CT7-2E1 ALERT SERVICE BULLETIN - 72- A0028 R01Revised:  
11/15/2023SB 72-A0028 R01 ENGINE - STAGES 1 AND 2 LOW-STRESS GGT ROTOR ASSEMBLY  
(72-41-00) - CT7-2E1 R88 CONTAMINATED HARDWARE REPLACEMENTIssued:  
02/01/2023

TRANSMITTAL INFORMATIONREVISION 1 TO ALERT SERVICE BULLETIN 72-A0028

Stages 1 and 2 Low-Stress GGT Rotor Assembly Disks and Cooling Plates  
Figure 1

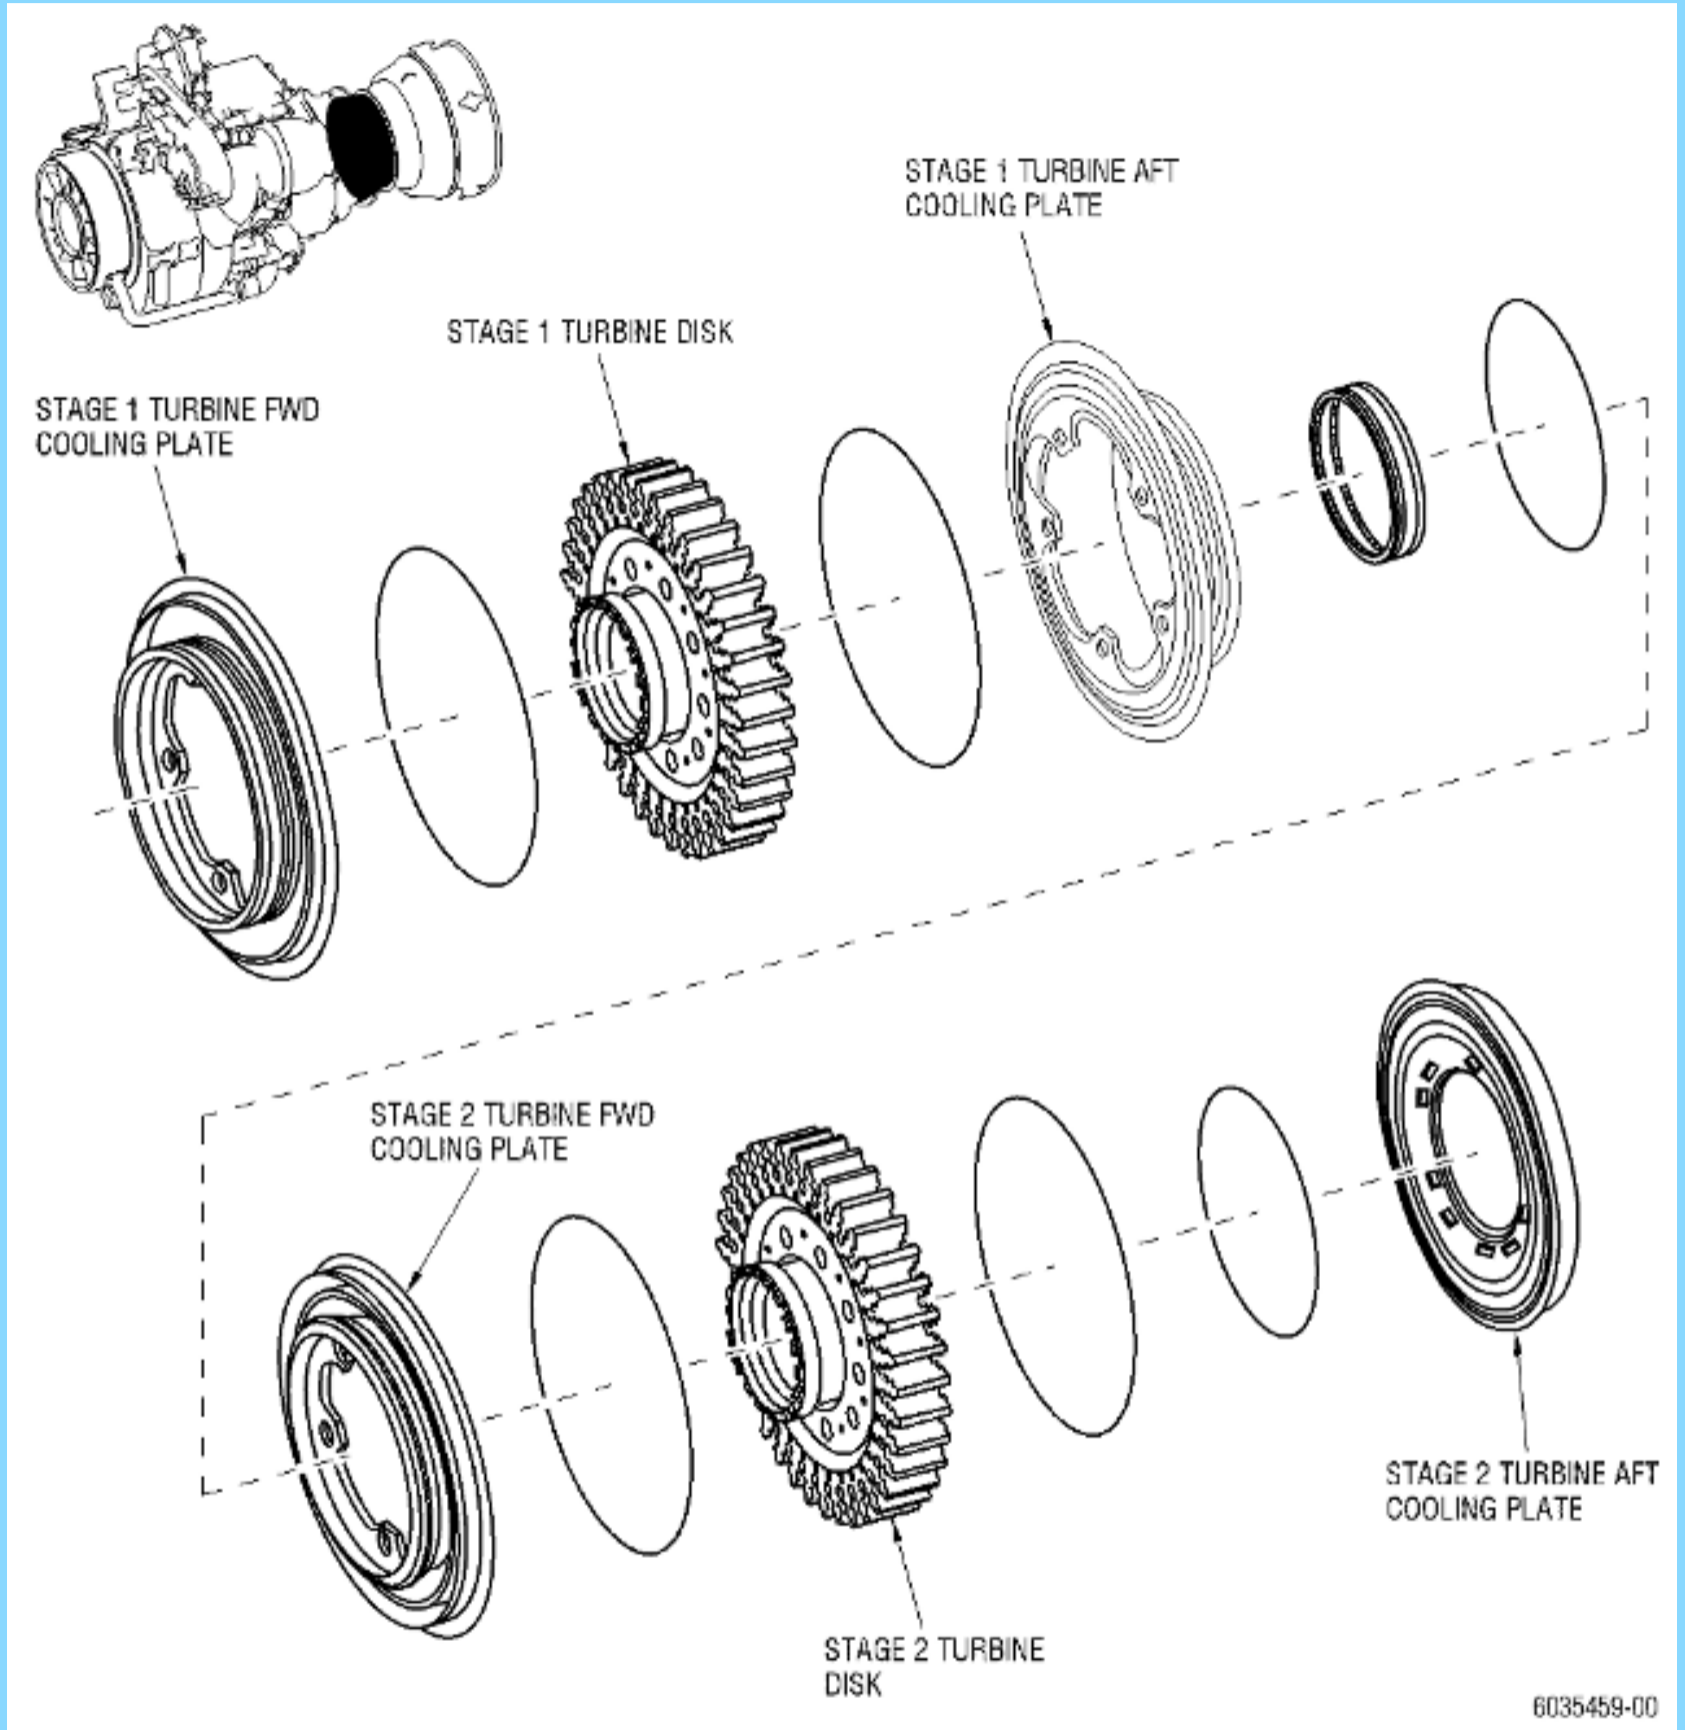
- (1) Remove the gas generator turbine rotor and stator assembly containing the potentially non-conforming stage 1 turbine disks (refer to figure 1). Refer to CT7-2E Maintenance Manual, GEK 112043-02, 72-40-00, REMOVAL AND INSTALLATION, TASK 72-40-00-400-801, applicable paragraphs.

- (2) Install a replacement matched gas generator turbine rotor and stator assembly P/N 5176T38G01. Refer to CT7-2E Maintenance Manual, GEK 112043-02, 72-40-00, REMOVAL AND INSTALLATION, TASK 72-40-00-400-801, applicable paragraphs.
